River Fly- In Condominium
 Unit: 702

04/12/2022

Framing

1.00-Beams and headers are correct size per plans/code.

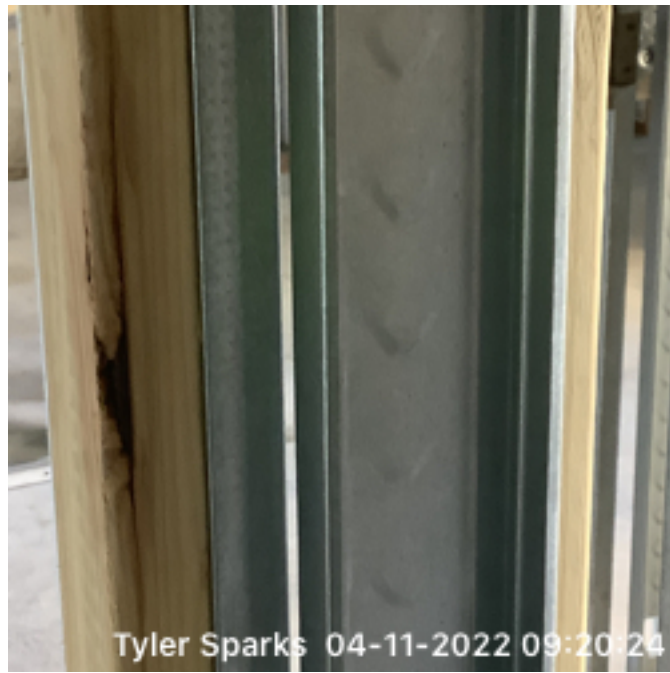
S - Satisfactory, the system meets plan/code/manufactures specifications
